Pursuant to our recent email exchange with Mr. Pearson, we have addressed the omission and oversights in Revision 2 of our proposed Part 71 Quality Assurance Program. To simplify matters, we request that Revision 2 be withdrawn from consideration and replaced with the enclosed Revision 3 of our Quality Assurance Program, document QAP-2-1, .

Procedure	QA Program for 20WC Users
Revision	3
Date	April 2006
Approval	Jerry P. Wiza, President

Quality Assurance Program

Figure 1. RAM Services QA Organization, Document QAP-1-1.

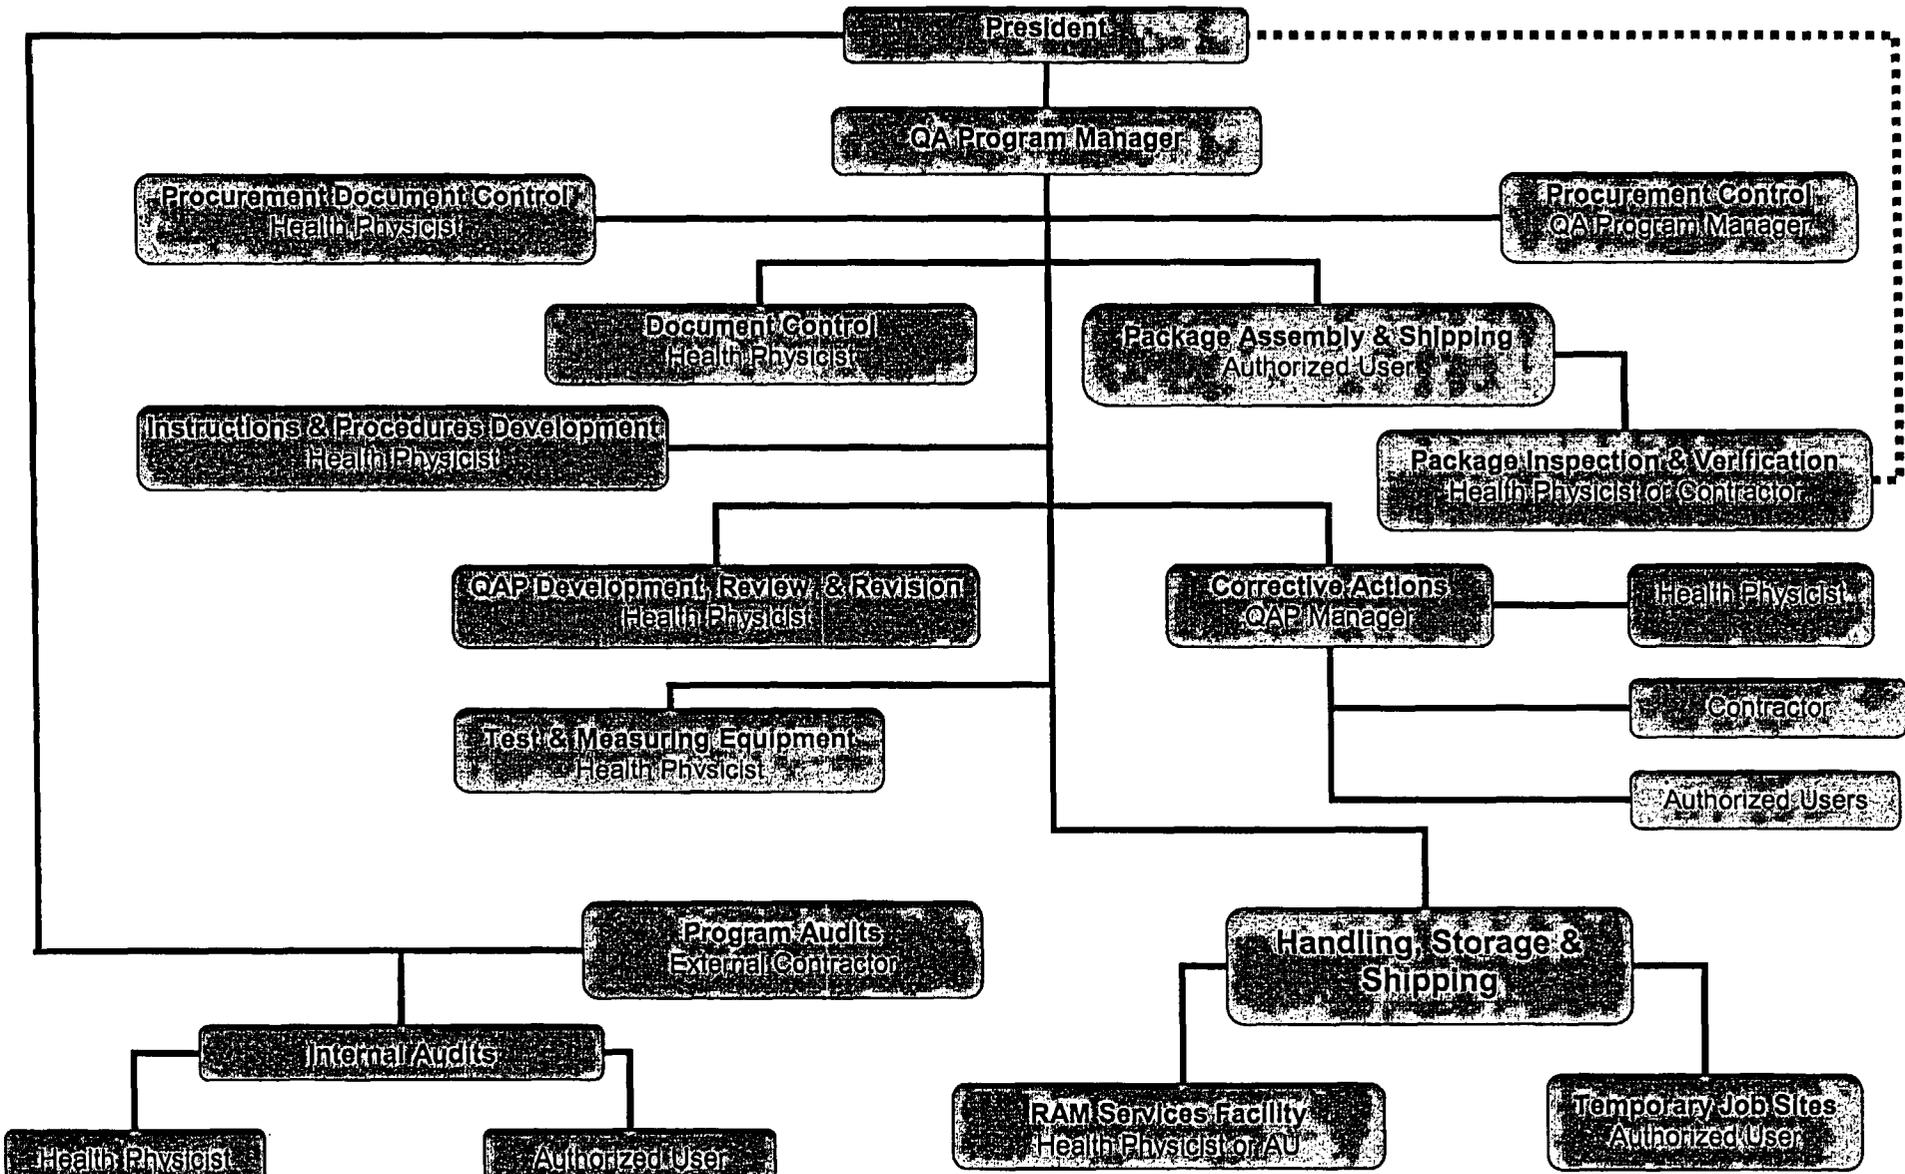
1. The Organization Chart has been revised so that the person performing Package Inspection & Verification will additionally report directly to the President.
2. We added a new paragraph at the end of section 2.3 that defines the qualifications of vendors of calibration services. I also added their certifications of compliance with a recognized procedure to Section 2.16 Records, under the Calibration Records caption. These documents will be controlled as QAP-4-2.
